1.0 Executive Summary

The purpose of this report is to review and assess the conceptual layout and mode of construction for the on-airport segment of the proposed Automated People Mover (APM) at Fort Lauderdale-Hollywood International Airport. The report focuses on the following four areas of interest:

4.0 Review of Automated People Mover Conceptual Support Structure at Rental Car Facility (RAC)

FIGURE 1
 BENT TYPE AND LAYOUT AT RAC
 AS PROPOSED BY EAC CONSULTANTS
 (BENT 1 THROUGH 9)

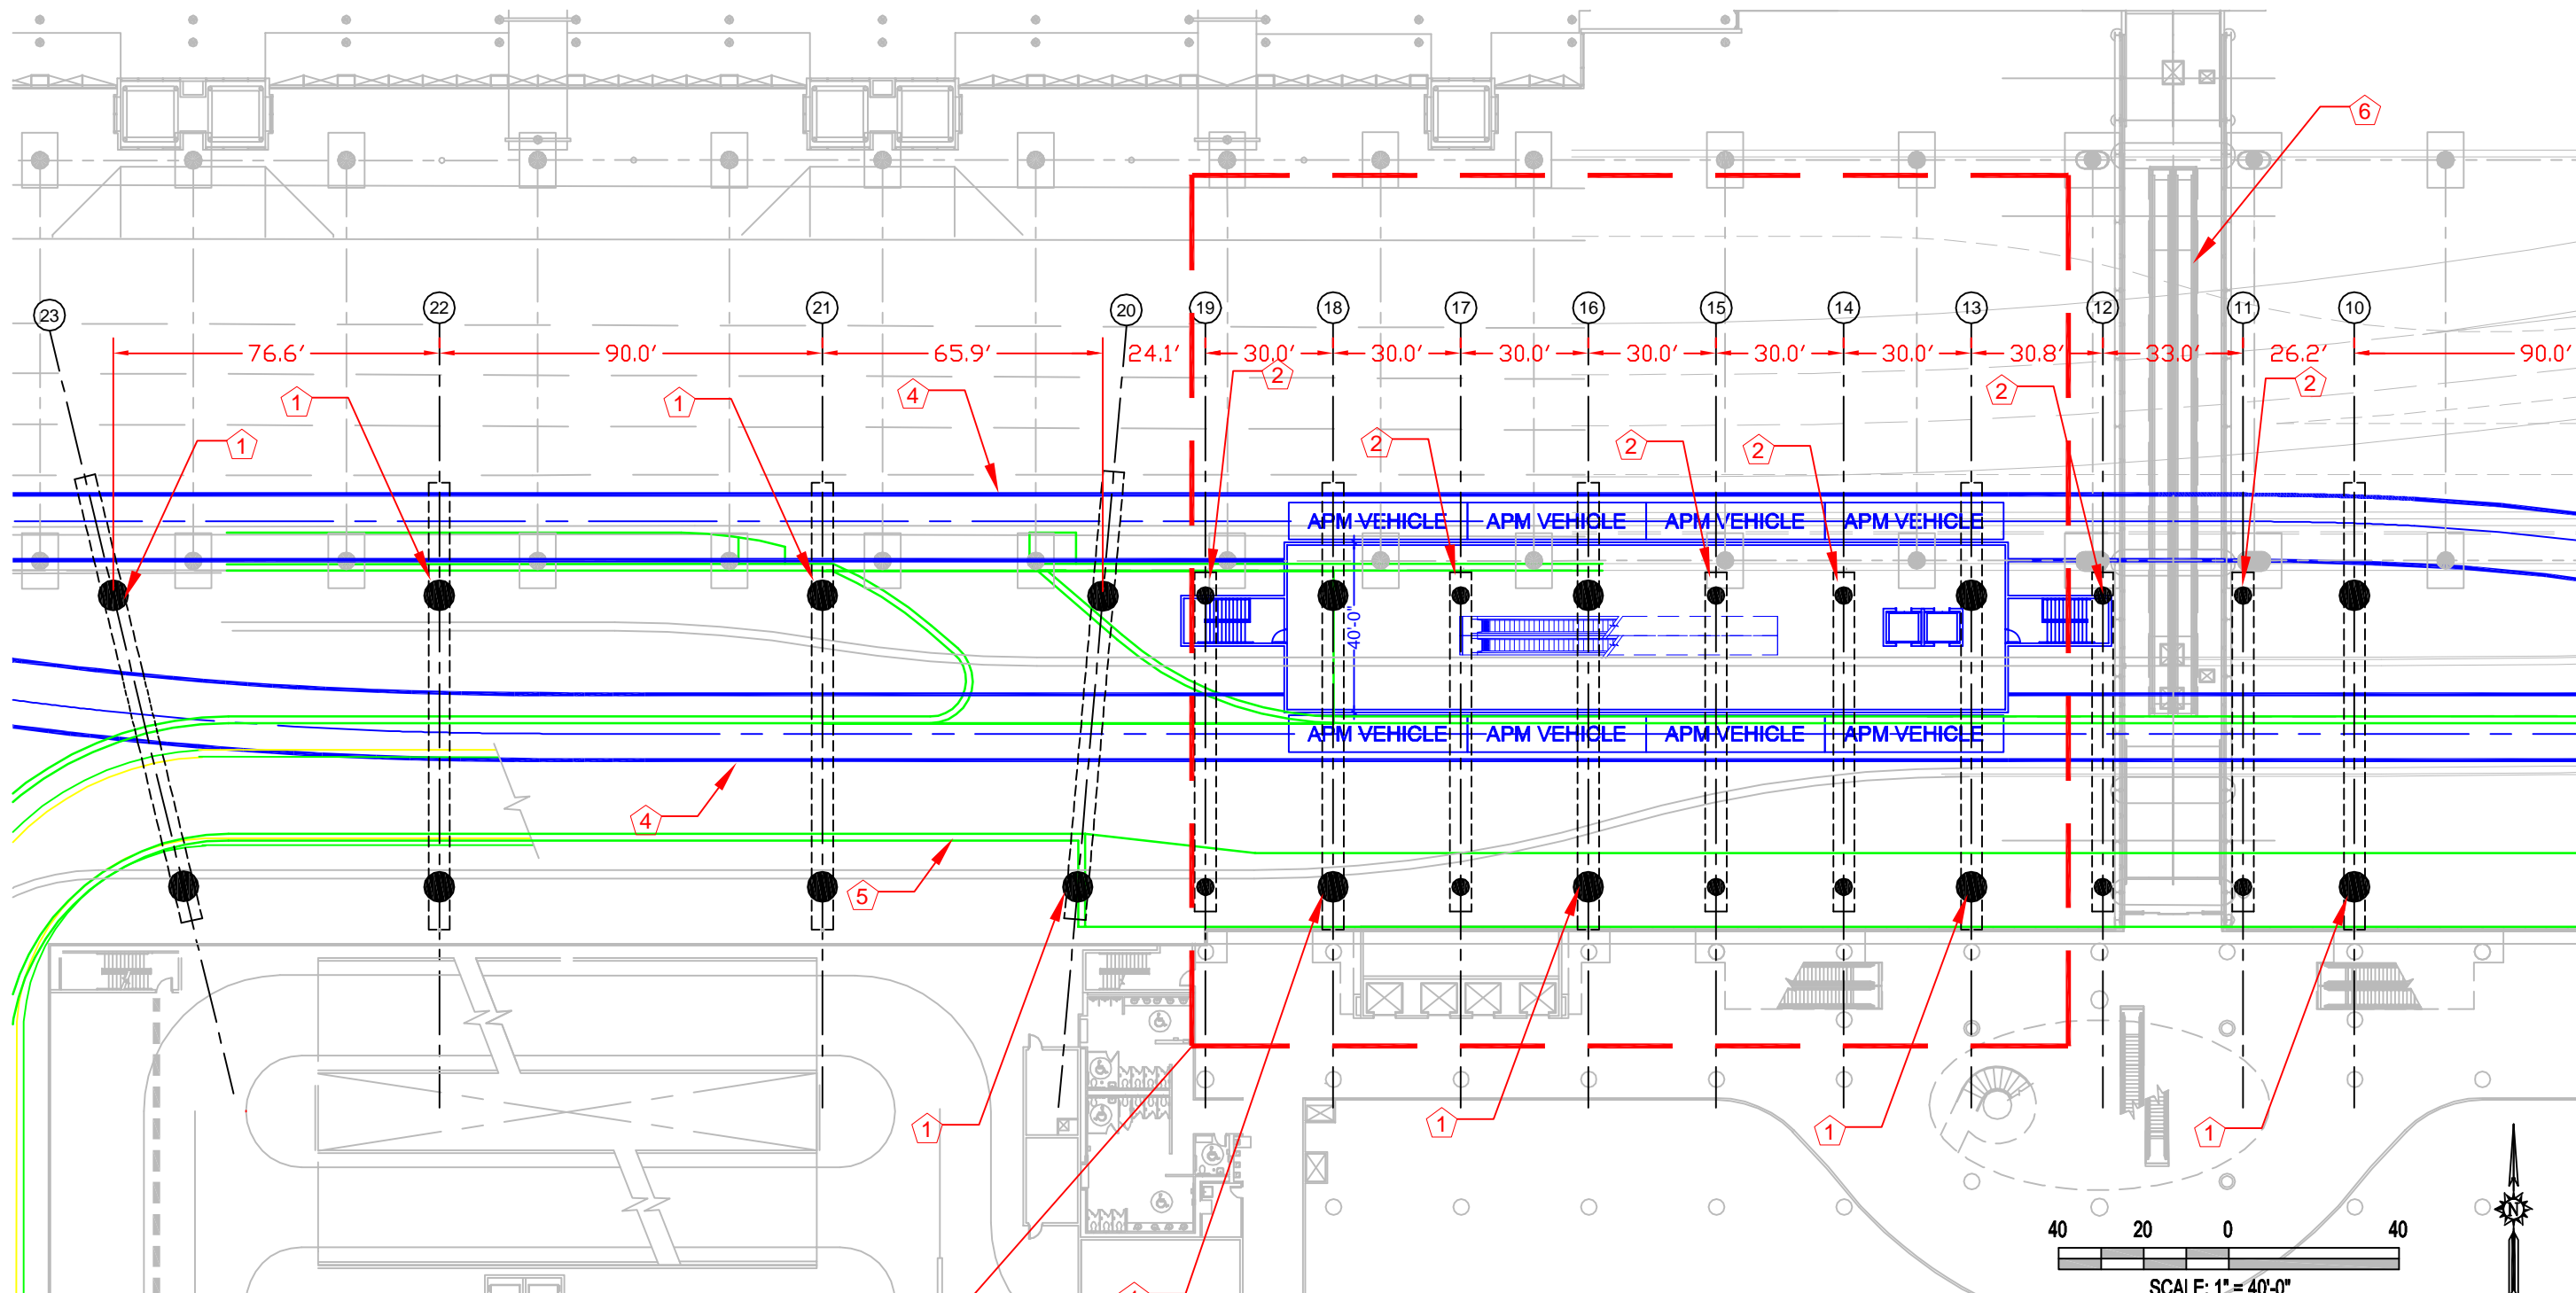
The layout and configuration of these bents is reflected on Figures 1 and 2. Bents 1 through 6, 11, 12, 14, 15,17 and 19 are bents designed to support Busway loads only. Bents 6A through 10, 13, 16, 18, and 20 through 23 are designed to support both Busway and APM loads (See Figures 5 and 6). The only bent shown in their report as required to

The EAC design calls for the single column bent with cantilevered beam to be used at the location just West of bent 5. Our analysis has indicated that due to the eccentric loading at this bent the superstructure as well as the foundations required would be excessively large. This would make the construction of this type of bent undesirable from both economically as well as from a constructability standpoint. There are two options for accomplishing this. The first one is to construct a portal frame, which will carry both the Busway and the APM loads as shown on Figure 8, Option 1. The plan layout for this option is shown on Figure 3. The second option is to shift the APM alignment further South in order to eliminate the eccentricity of the bent (Figure 8, Option 2). The second option would only require that one column be extended in the future for support of the APM guideway. The plan view of Option 2 is shown on Figure 3A.

The EAC design also calls for bents 1, 2, 3 and 5 to only carry Busway loads. Due to the fact that the horizontal alignment of the APM guideway falls virtually on top of the Busway at bents 3 and 5, we believe that a combined bent would be more desirable option (See Figure 3). This would reduce the future construction cost of the APM as well as reduce the impact that future construction would have on the operations of the Airport.

In addition to performing a structural analysis of the support structure for the APM and Busway construction we have also reviewed the layout of the foundation system for the proposed APM support structure with a view of identifying any conflicts with site utilities (See Figures 9 and 10). The following is an outline of possible conflicts

FIGURE 4
 ALTERNATIVE BENT LAYOUT
 (BENT 14 AND 15)

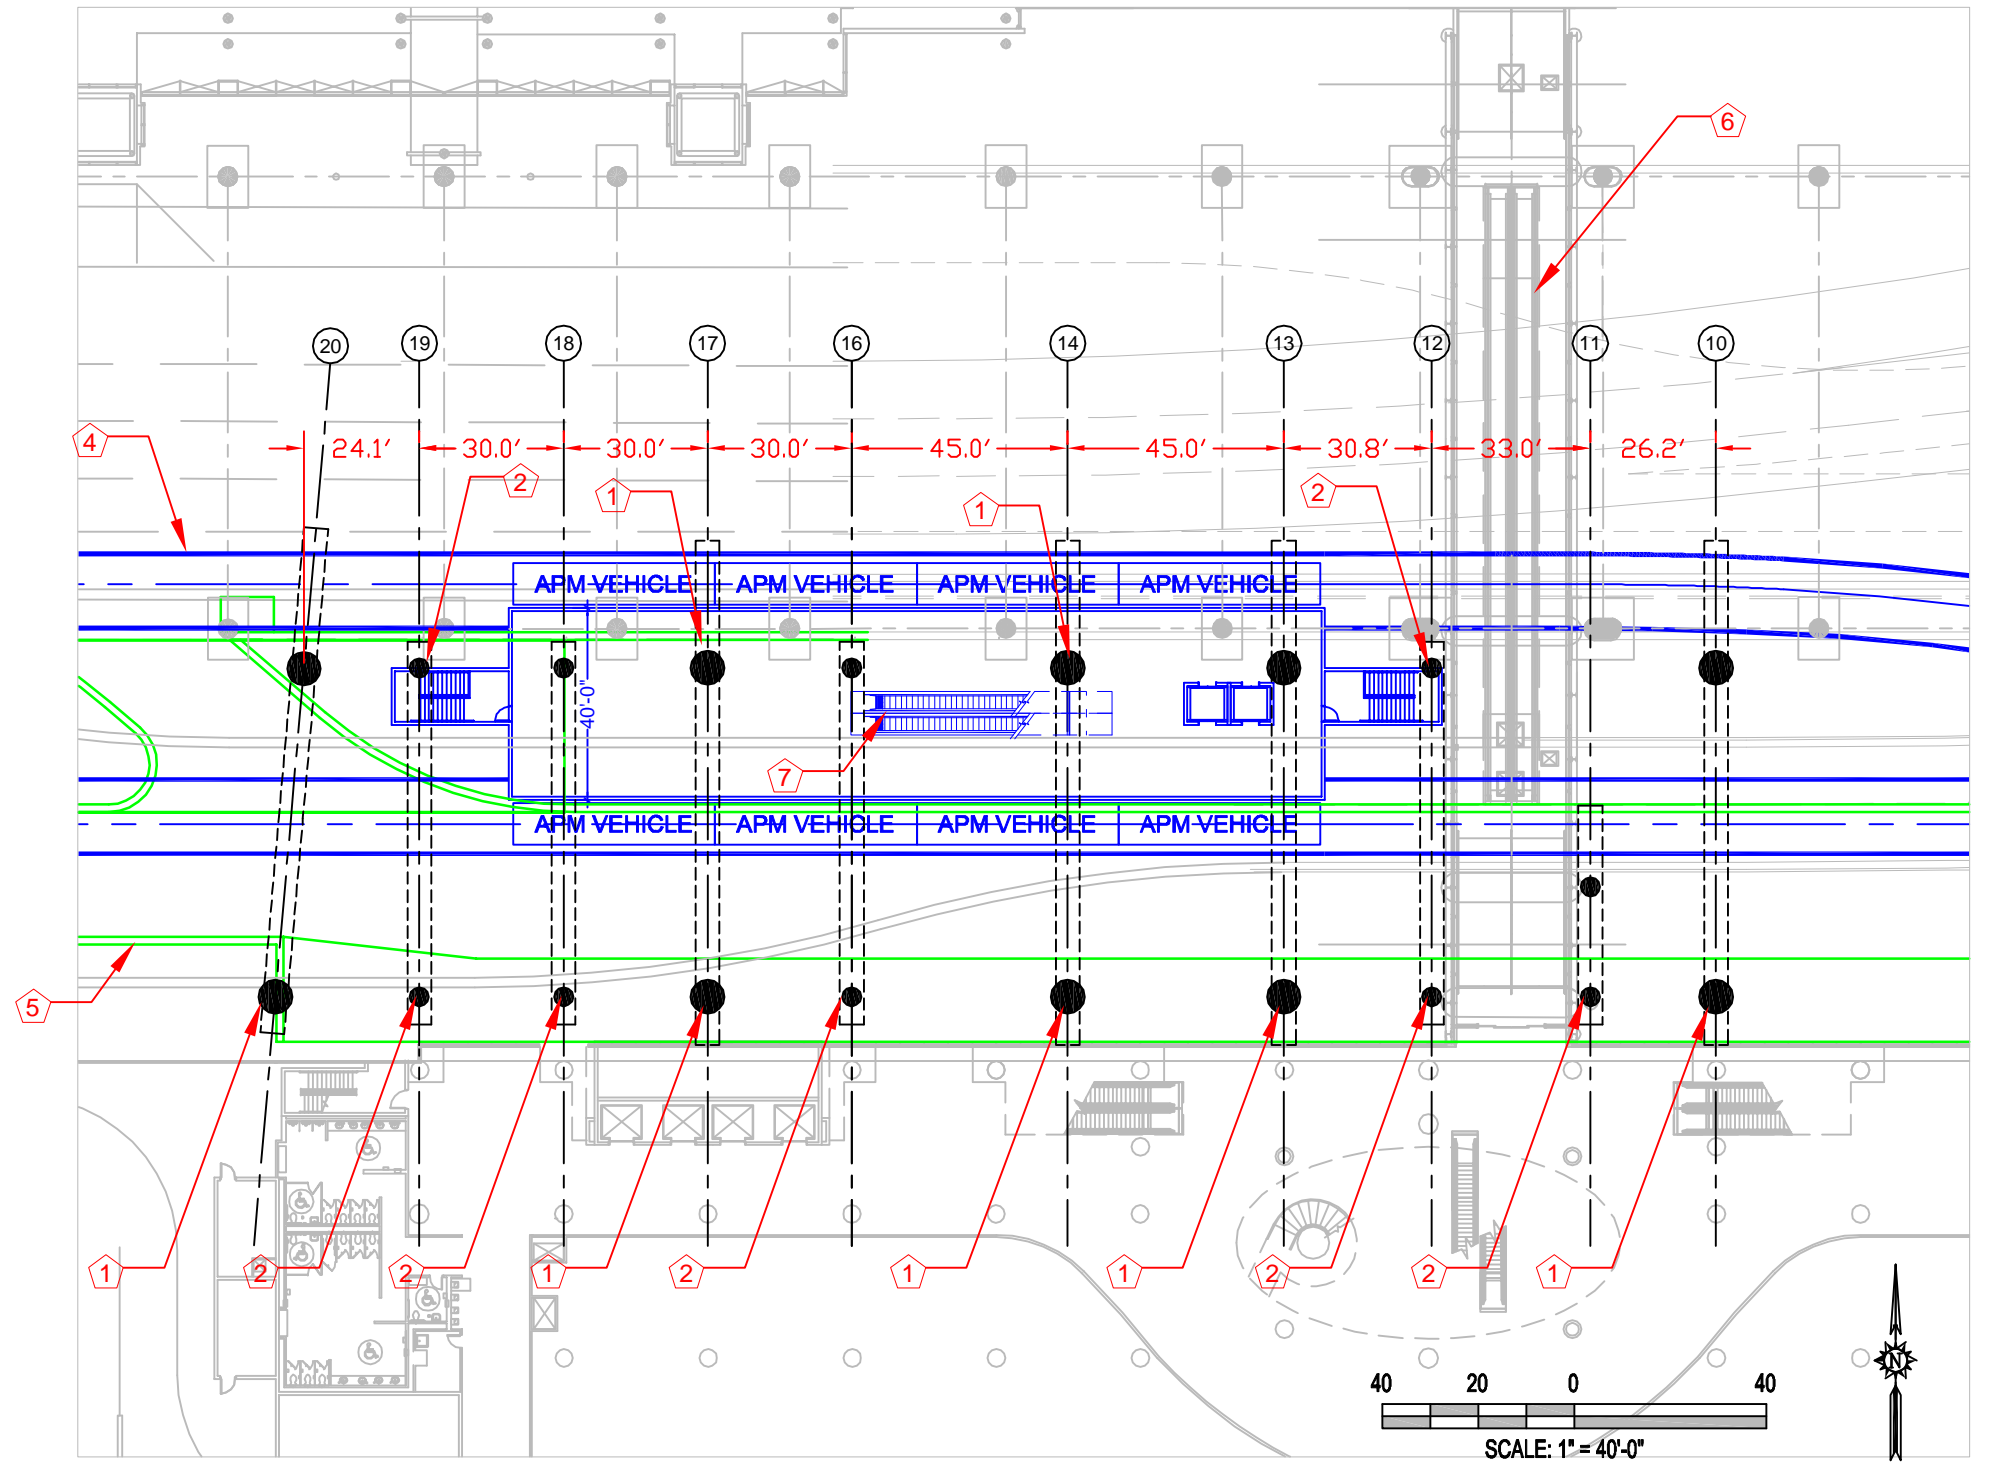
Another possible conflict appears to exist between the framing system of the Busway/APM structure and the escalator penetrations at Terminal 1. The head room required by the escalator leading from the 2nd floor to the 3rd floor of the Terminal can not be achieved at bent 15. We have identified the following possible solutions to this problem:

1. Maintain the proposed bent spacing of 30' and design a shallower transverse member for this bent. This could be accomplished by incorporating a double beam design that would straddle the pier cap at this location (steel beams would be required).
2. Eliminate bent 15 in its entirety and move bent 14 fifteen feet further West (See Figures 4 and 4A). This would generate a bent spacing of 45' at this location instead of 30'. Bents 14 and 17 would support both APM and busway loads and bent 16 would now support the busway only.

These options require that the Busway design team perform an additional analysis in order to establish construction feasibility. Option 2 is primarily controlled by the Architectural requirements of Terminal 1. From an economic and constructability standpoint option 2 above would be the preferred option.

FIGURE 5
TYPE "A" BENT
TYPICAL BENT SUPPORTING BUSWAY
AND FUTURE APM AT TERMINAL NUMBER 1
(BENT 13, 16 AND 18)

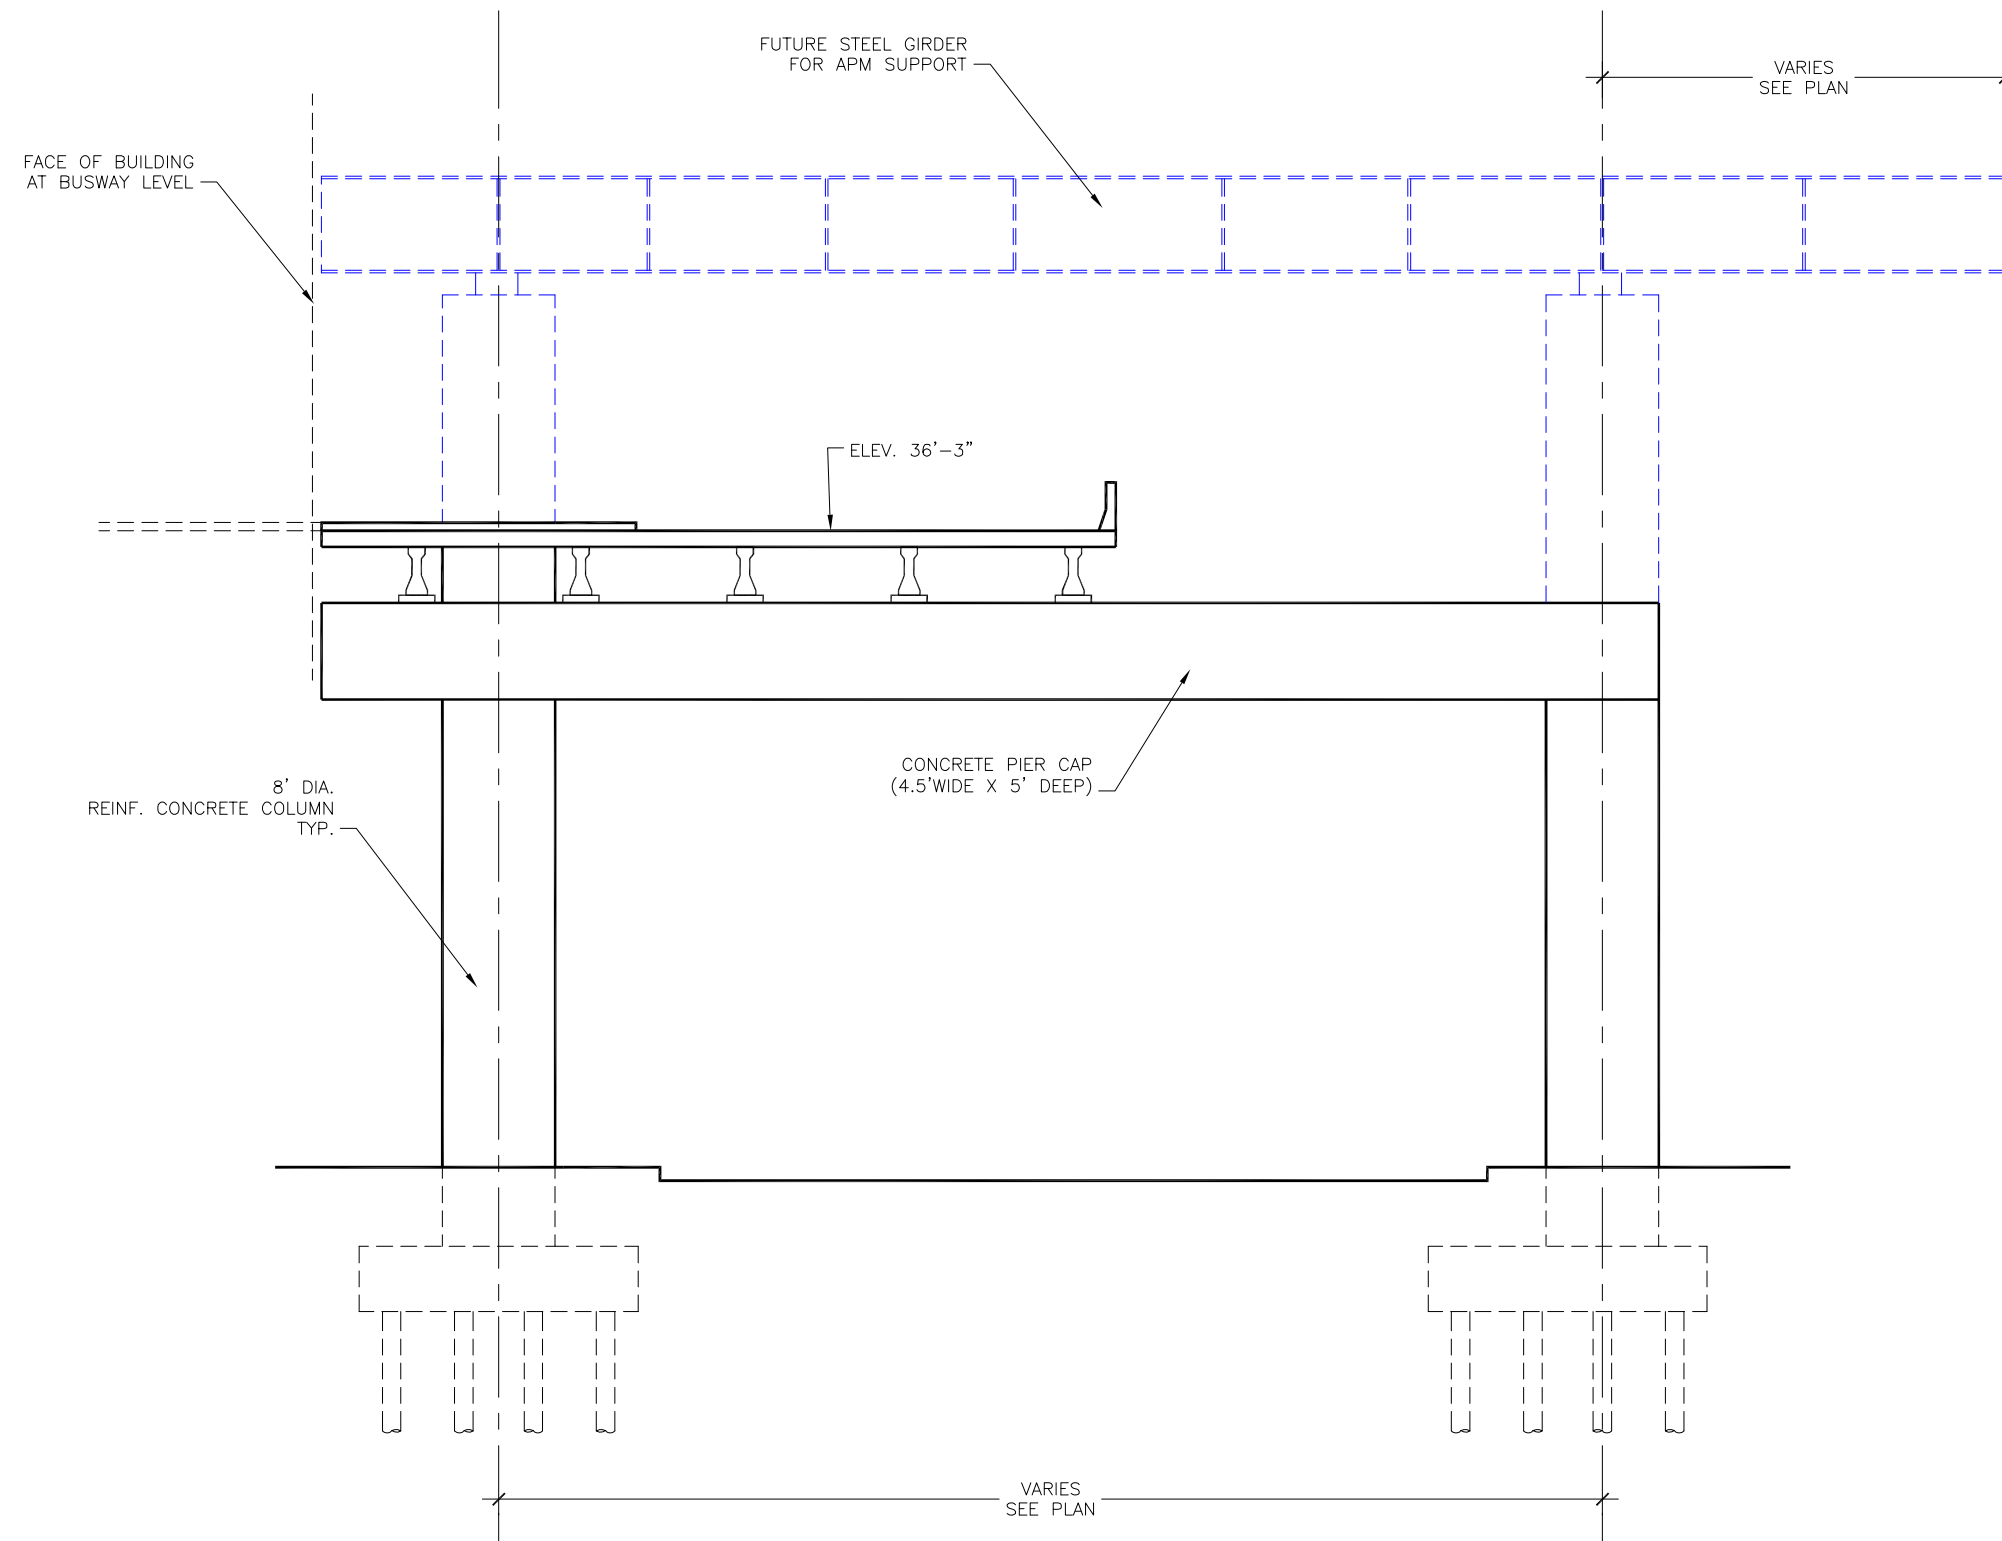
support APM loads only is located just West of bent 5 (See Figure 7). Of the bents required to support Busway and APM loads combined, bents 13, 16 and 18 also support the loads generated by the APM platform on levels 2, 3 and 4 (See Figure 5).

The design near the RAC calls for straddled bents, which are more stable than single column bents. A preliminary analysis of a straddled bent carrying two APM tracks results in 60" diameter concrete columns or 36"x72" elliptical columns. The elliptical columns would be more cost effective however site constraints may dictate that the circular columns be used. These columns however will have to be increased due to the additional loads generated by the Busway. We anticipate that the diameter required to support all of the loads will be around 84".

In the above analysis the columns require sixteen (16) auger cast piles of 250-ton capacity. The proposed size of foundations is 16' x 16'. Hence the thirty (30) piles proposed in the report submitted by EAC Consultants seems to be in excess. A possible reason for this is that the highest reactions developed anywhere along the proposed alignment was used for the design of all the foundations. This would be consistent with our analysis for the bent type shown on Figure 7 where a single column with a cantilever beam carries two APM guideways.
